PROJECT NAME: FAIRFIELD  
PROJECT NUMBER: BRO 1448(38)

FILE NAME: z1j072exc\_01.dgn  
PROJECT LEADER: D. LANDRY  
DESIGNED BY: E. ALEXOPOULOS  
TYPICAL SECTIONS (2 OF 2)

PLOT DATE: 05-DEC-2013  
DRAWN BY: W. GAYNOR  
CHECKED BY: T. KENDRICK  
SHEET 4 OF 41

**COFFERDAM NOTES**

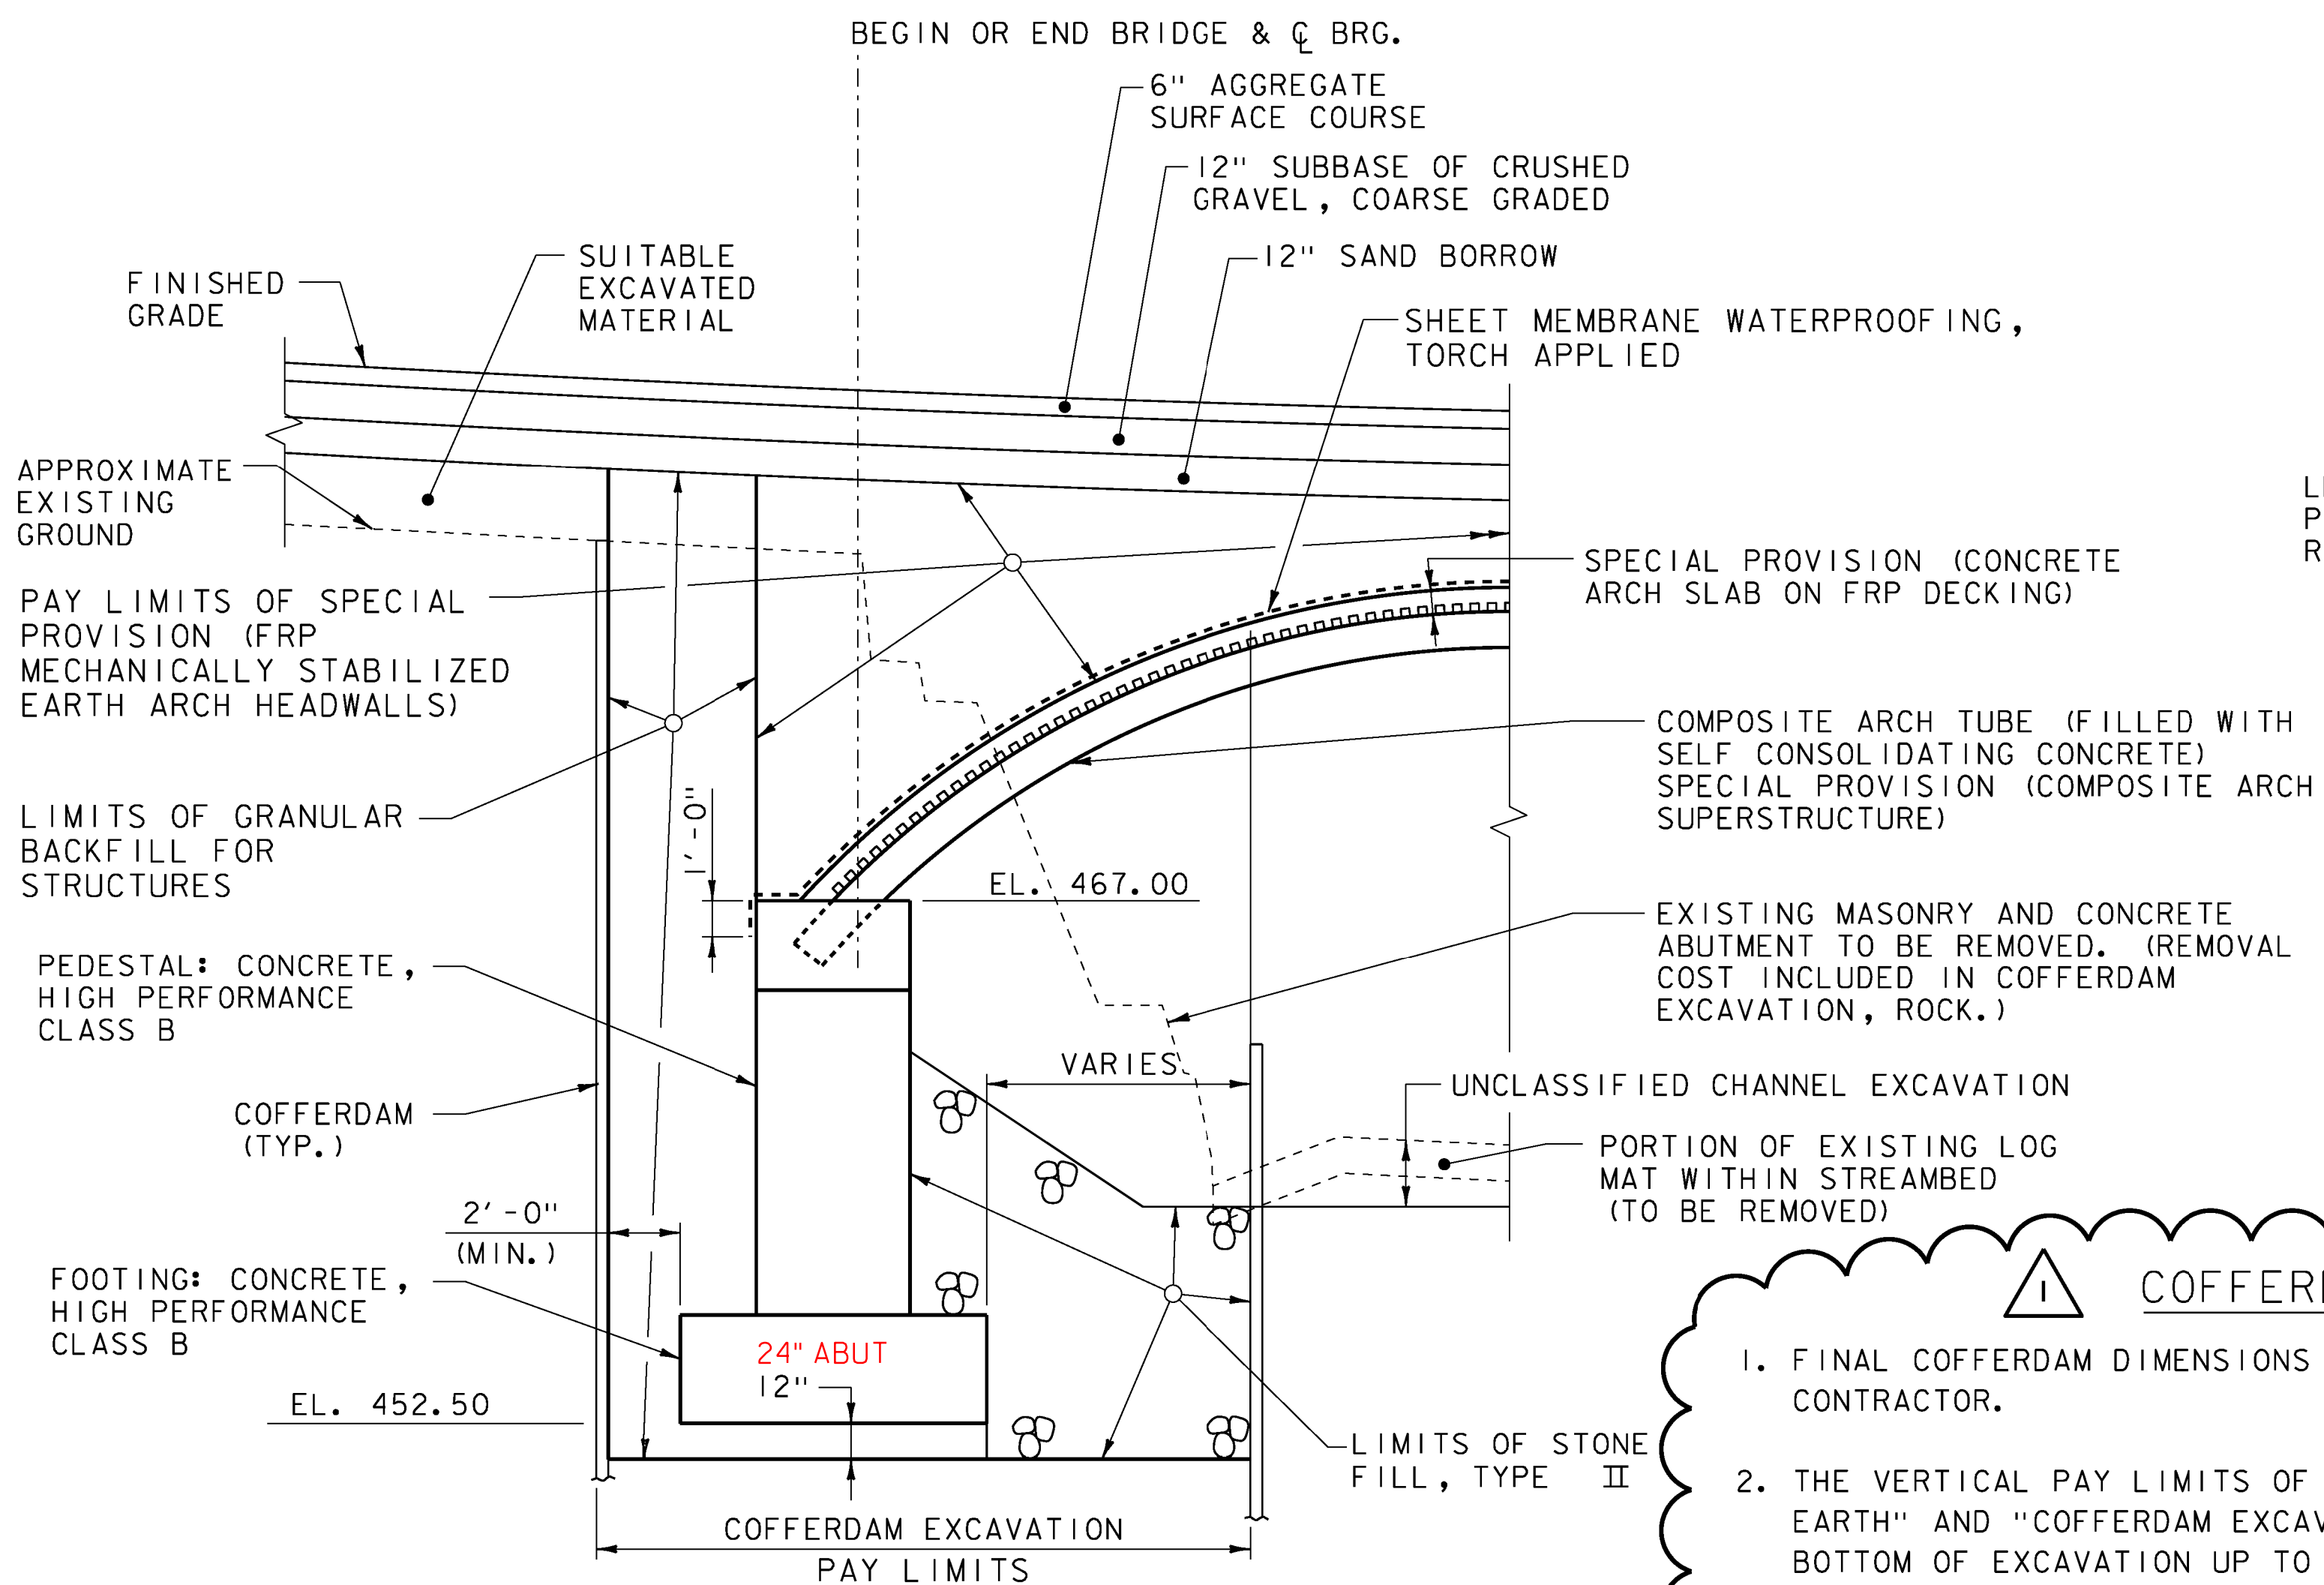
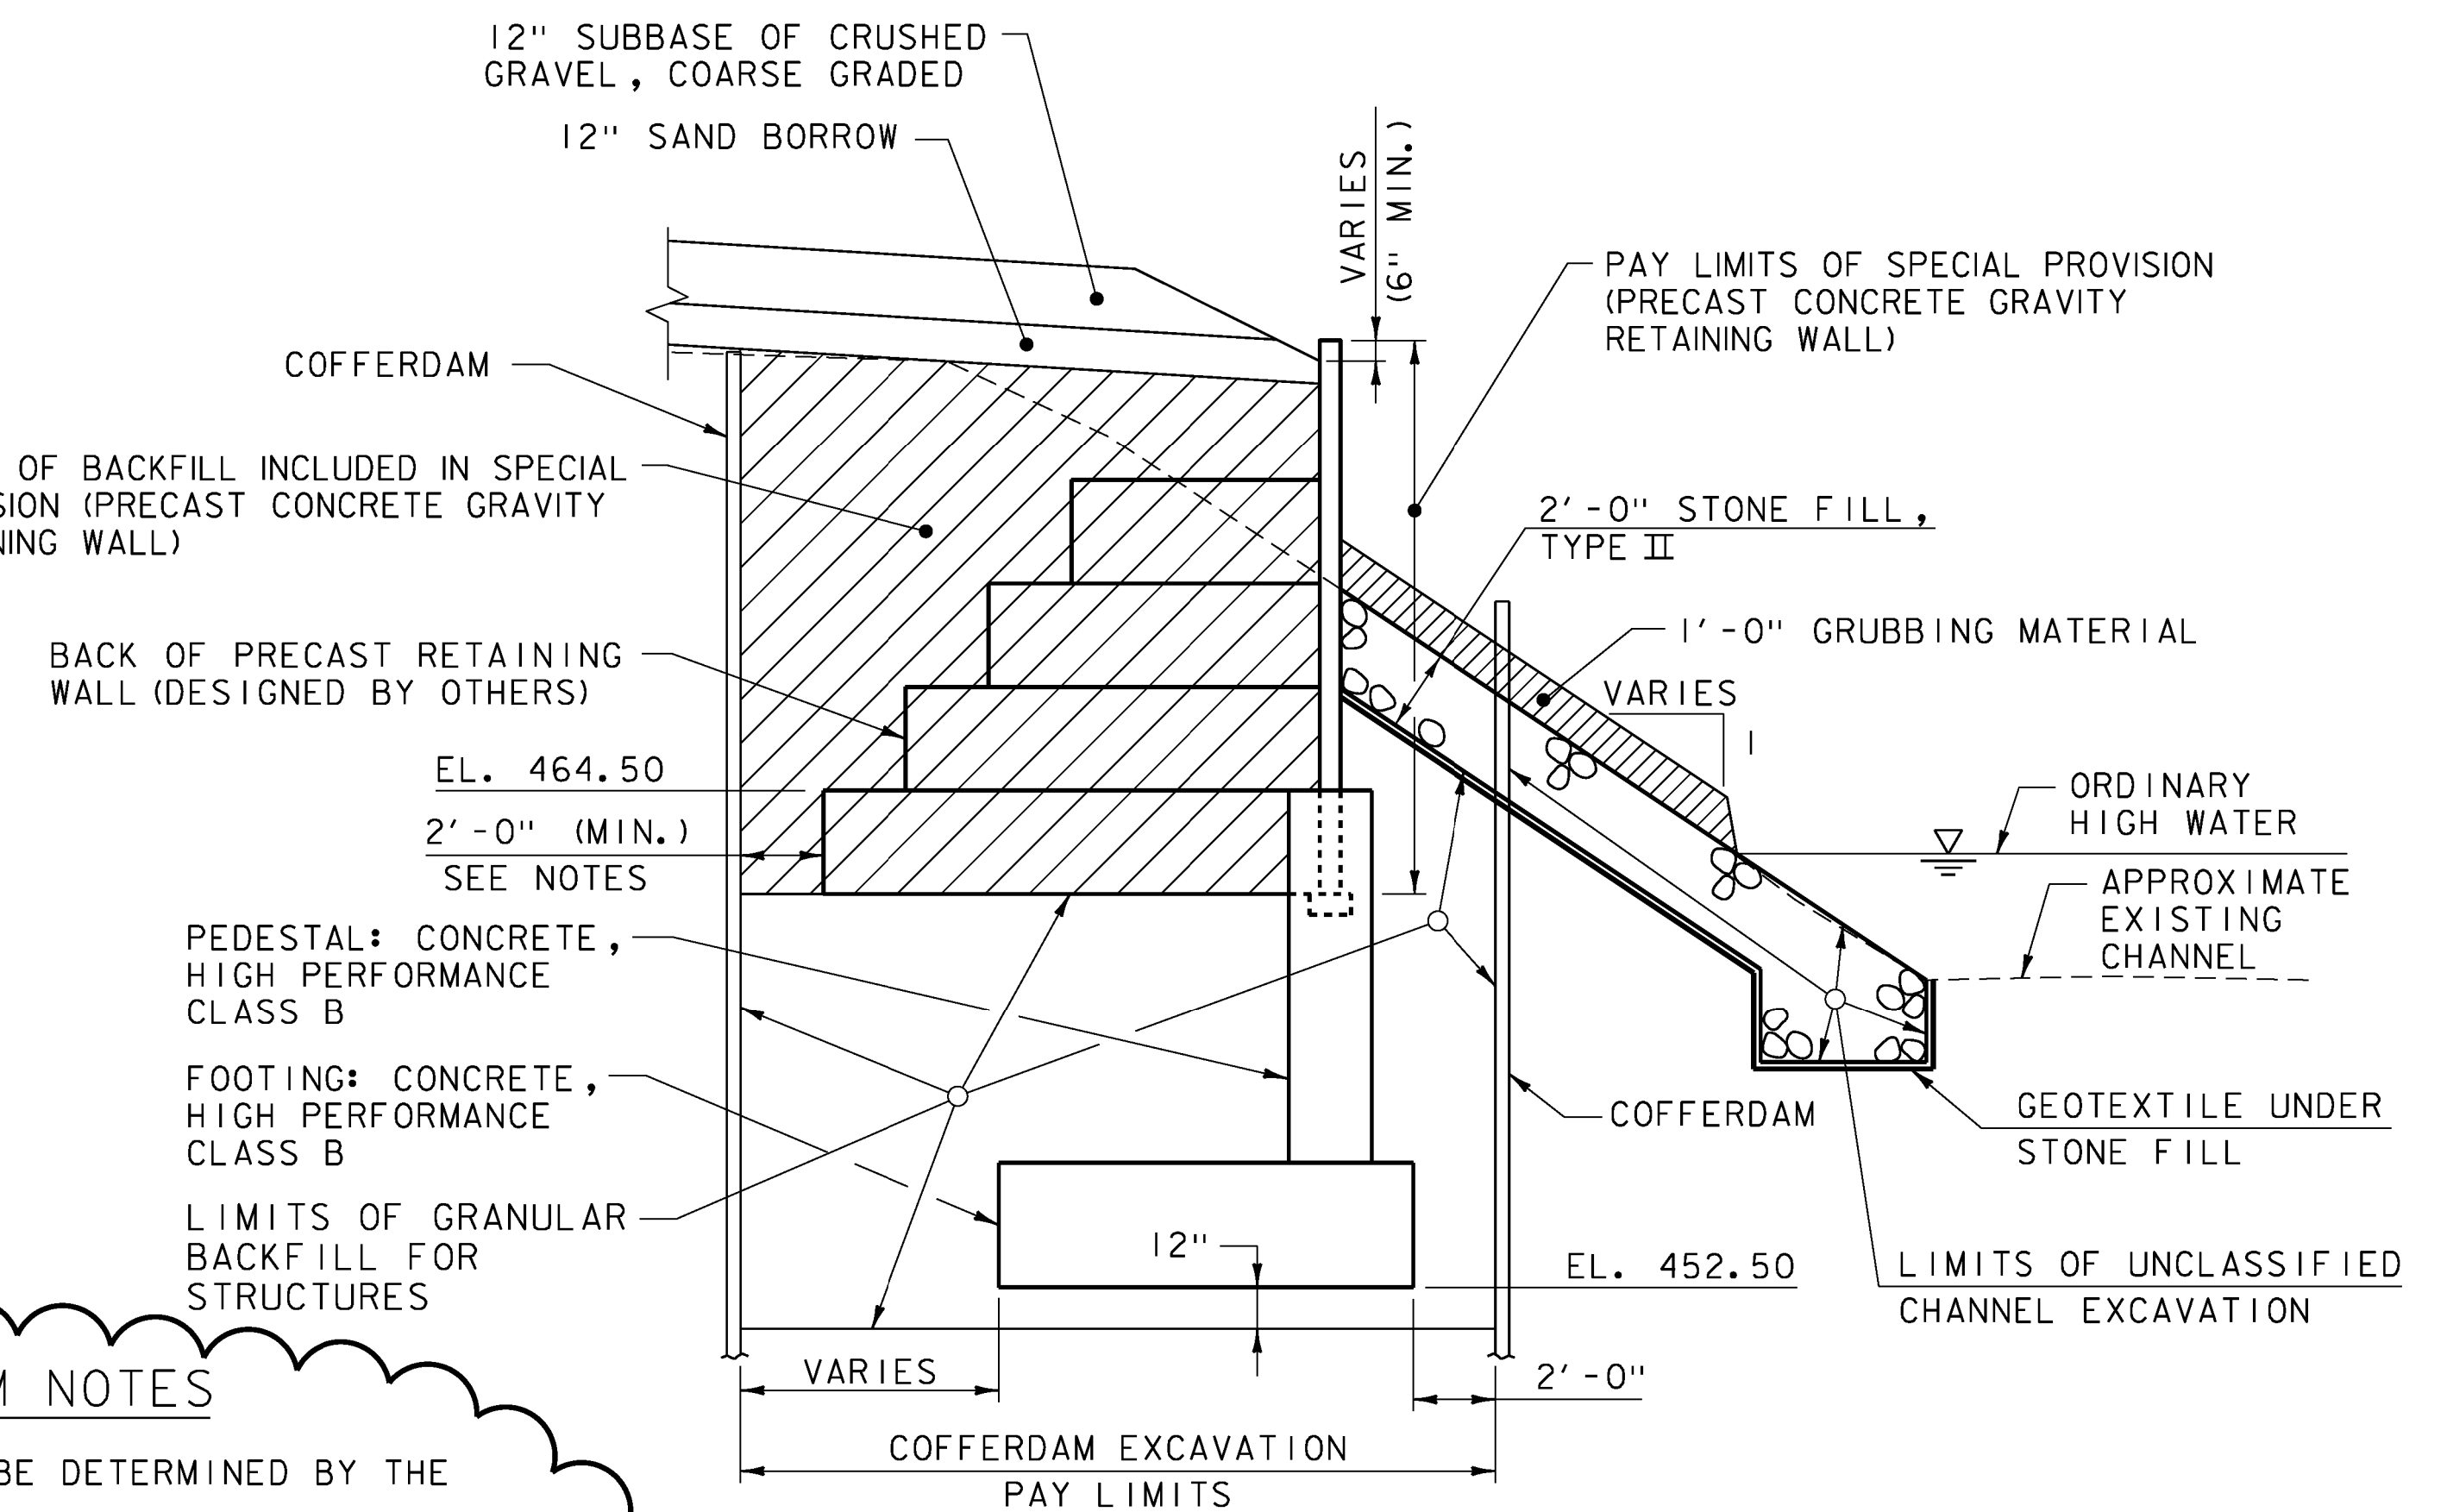
△ COFFERDAM NOTES REVISED 12/13

1. FINAL COFFERDAM DIMENSIONS TO BE DETERMINED BY THE CONTRACTOR.
2. THE VERTICAL PAY LIMITS OF EITHER "COFFERDAM EXCAVATION, EARTH" AND "COFFERDAM EXCAVATION, ROCK" SHALL BE FROM BOTTOM OF EXCAVATION UP TO THE EXISTING GROUND OR BOTTOM OF SUBBASE, WHICHEVER IS LOWER.
3. IF A COFFERDAM IS CONSTRUCTED WHICH IS LARGER THAN THE INDICATED COFFERDAM EXCAVATION PAY LIMITS, PAYMENT FOR ALL UNCLASSIFIED CHANNEL EXCAVATION, INCLUDING THAT PORTION WHICH IS INSIDE THE COFFERDAM BUT OUTSIDE THE COFFERDAM PAY LIMITS, WILL BE MADE AT THE CONTRACT UNIT PRICE FOR UNCLASSIFIED CHANNEL EXCAVATION. NO MEASUREMENT AND PAYMENT WILL BE MADE FOR COFFERDAM EXCAVATION AND GRANULAR BACKFILL FOR STRUCTURES OUTSIDE THE PAY LIMITS DETAILED ON SHEET 15.
4. FOR PAY LIMITS OF COFFERDAMS, SEE SHEET 15 AND SUBSTRUCTURE NOTE 4 ON SHEET 5.
